SUMMARY EXPERT OPINION
**INDEPENDENT CERTIFICATION:
OVERSHADOWING ANALYSIS**

PROPOSED MULTI RESIDENTIAL DEVELOPMENT
10-14 Merton St Sutherland

22 December 2014

Figure 1: View from the sun 12 noon

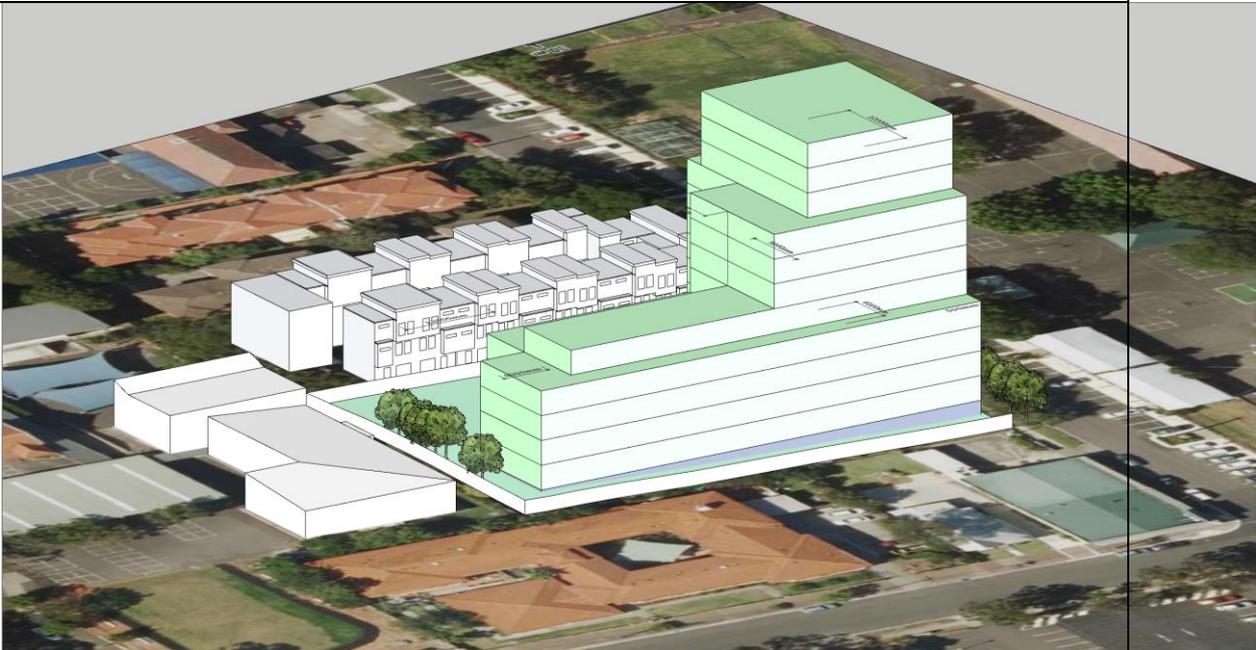
I have prepared my own hourly views from the sun for the architects' preferred option. The technique is illustrated in Figure 1. I attach a table of hourly views from the sun of Option 2, in Appendix A.

Figure 2: Critical envelope limits, Option 2 view from the sun 12 noon June 21

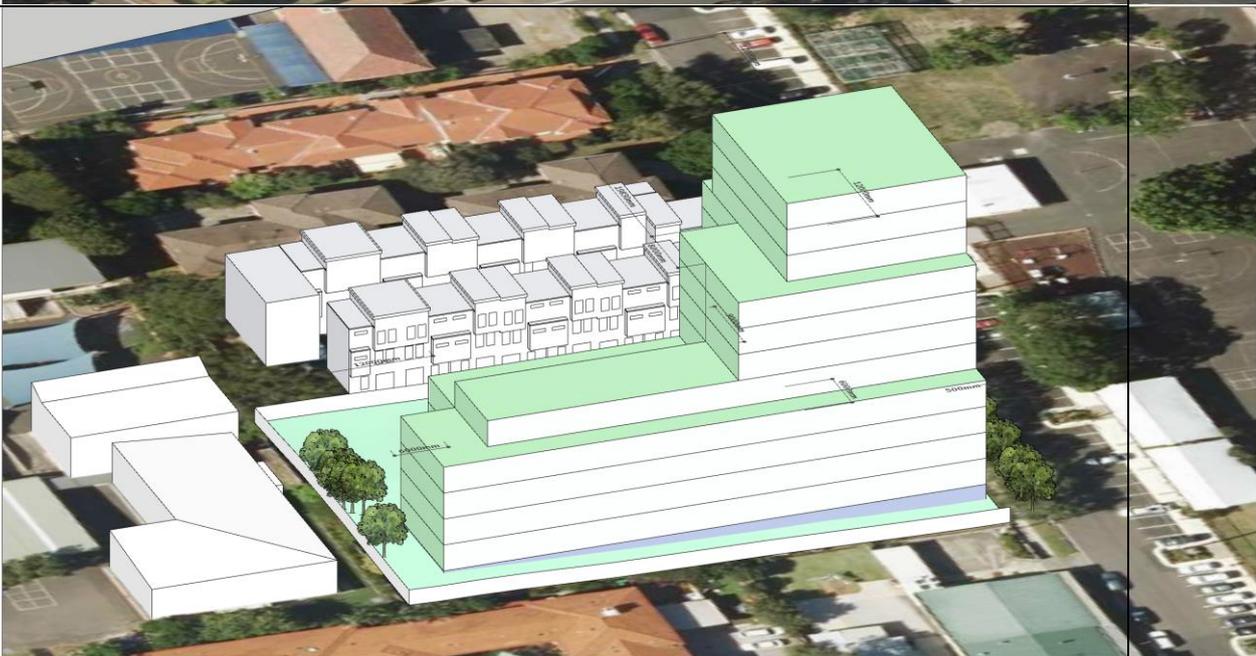
I refer again to my preferred technique of 'views from the sun'. Figure 2 uses the same base as Figure 1, but is annotated with some key considerations.

A Critical tower height:

- If tower is *taller*, it will have impacts to the south beyond that of the existing townhouses.
- *Reduction* in tower height does not make a significant difference in overshadowing of townhouses on immediately adjacent site.

B Critical podium height and location:

- Relevant parapet heights of podium in this location preserve solar access to ground floor of townhouses to the south of the subject site.

C Minimise overshadowing of schools to the east and west:

- In the middle of the day there is no overshadowing impact on the adjacent schools;
- The morning shadow to a portion of the playground of the primary school is determined by the plan, not the height of the 'tower';
- The afternoon shading of St Patrick's is from the identical 'podium' portion and is insensitive to the tower height.
